Addendum No. 5

Date: April 26, 2013

Reference: Regional Training Institute – TASS Phase 2
Utah National Guard – Camp Williams, Utah
DFCM Project No. 11020480

Subject: **Addendum No. 5**

1 EP102 **LEVEL 2 POWER PLAN**
1/8" = 1'-0"

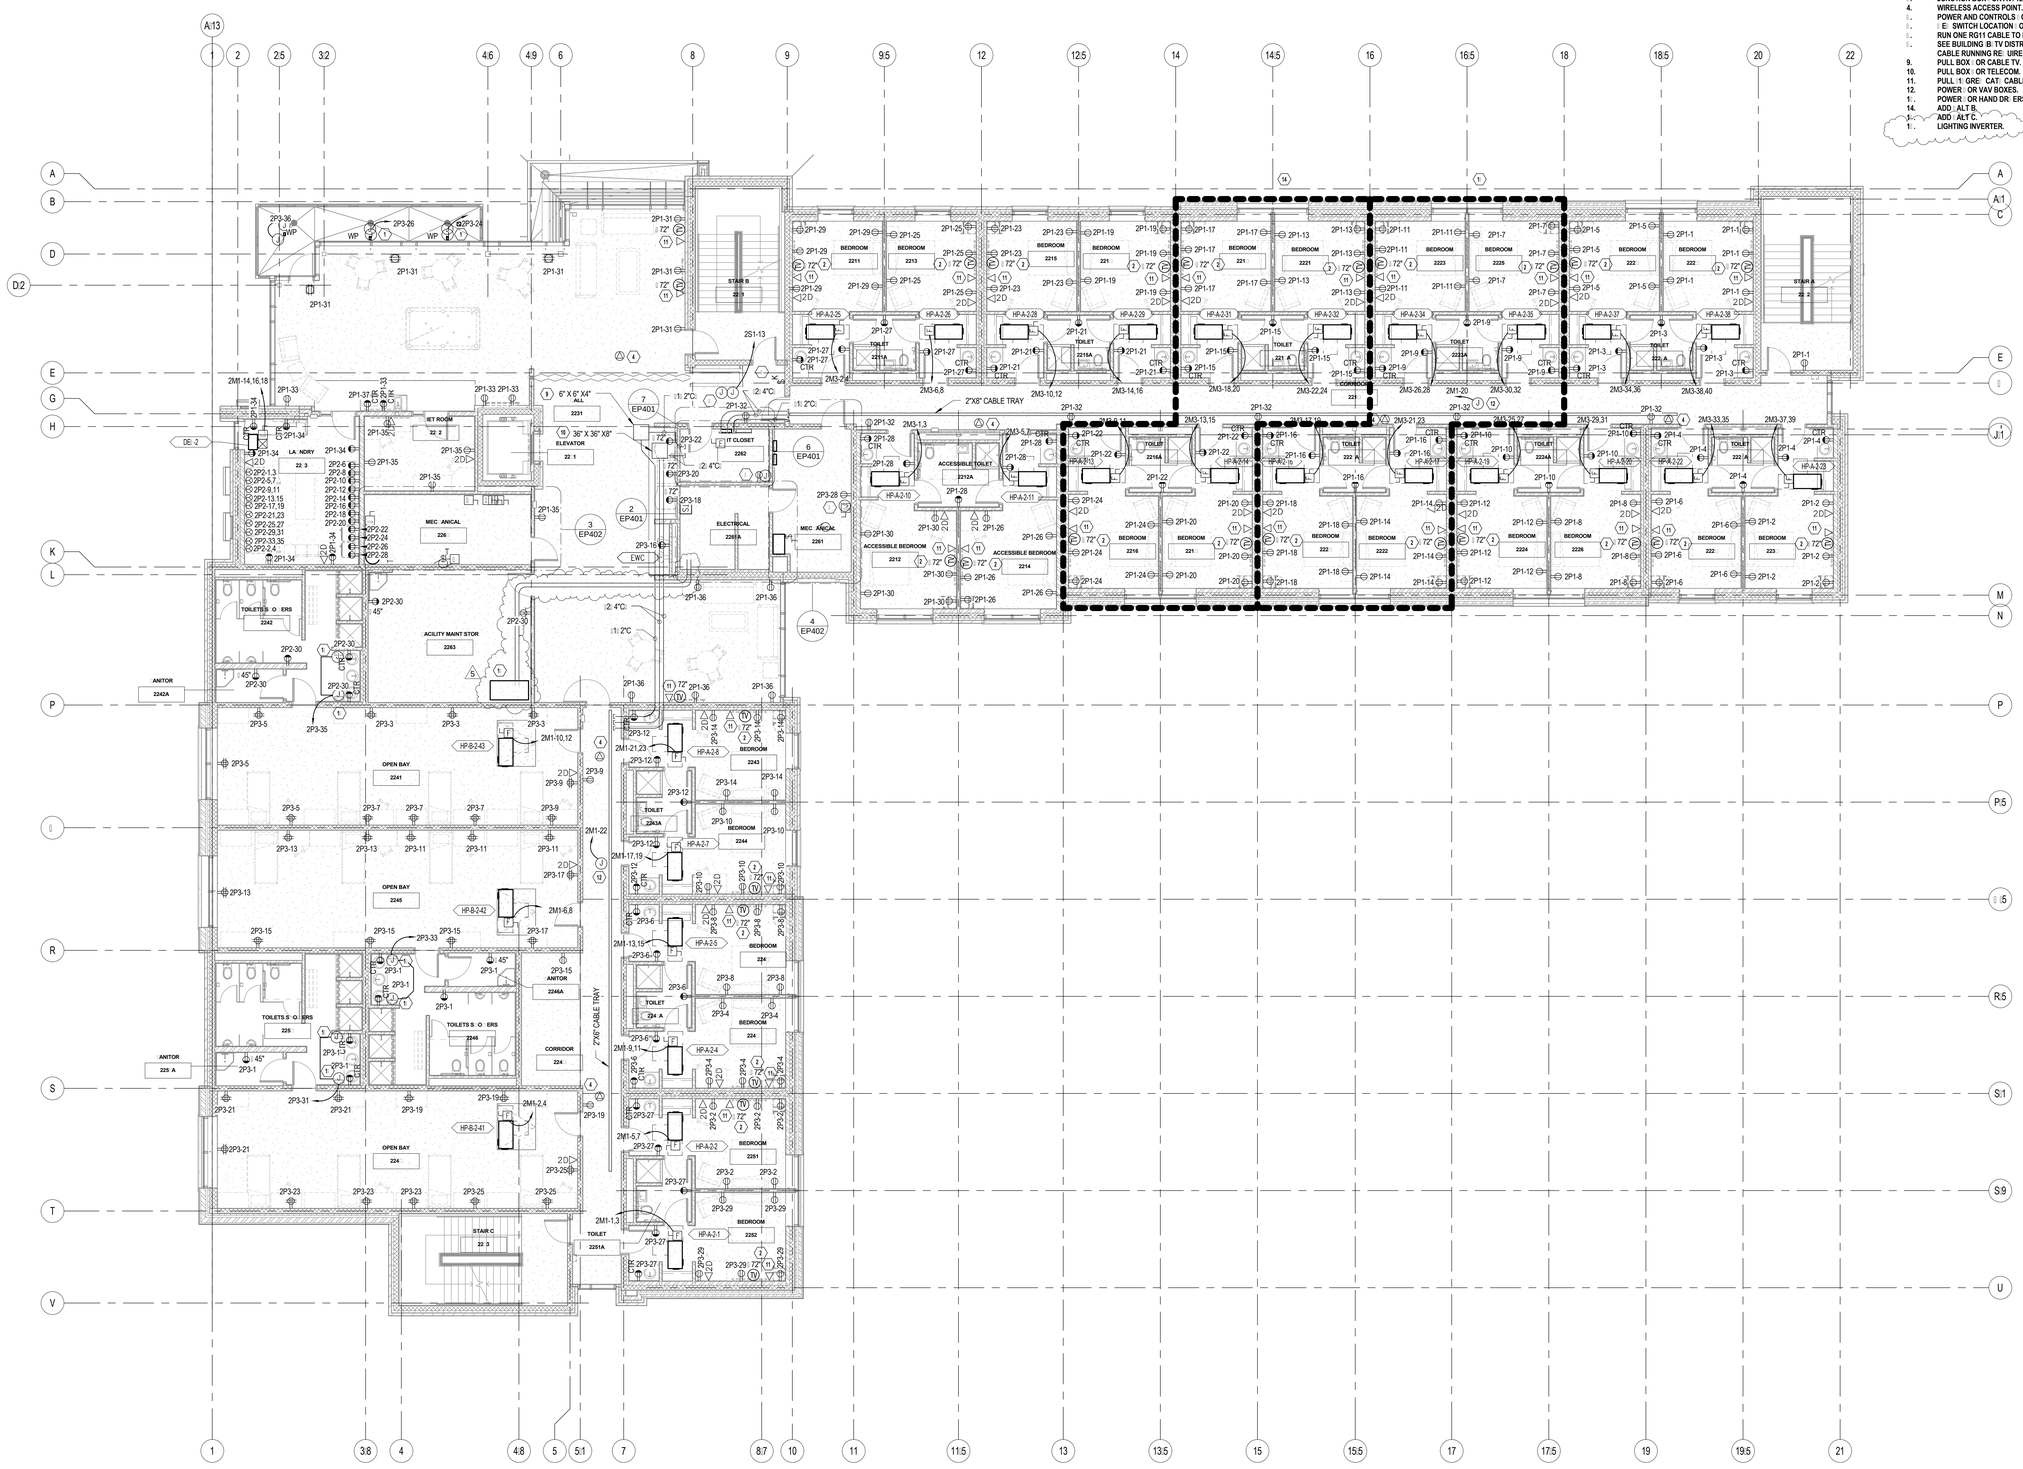
Sheet EP102
3. Place the emergency egress lighting inverter in room 2263 as shown on attached sheet.
4. Add keyed note 16 stating, “LIGHTING INVERTER”.
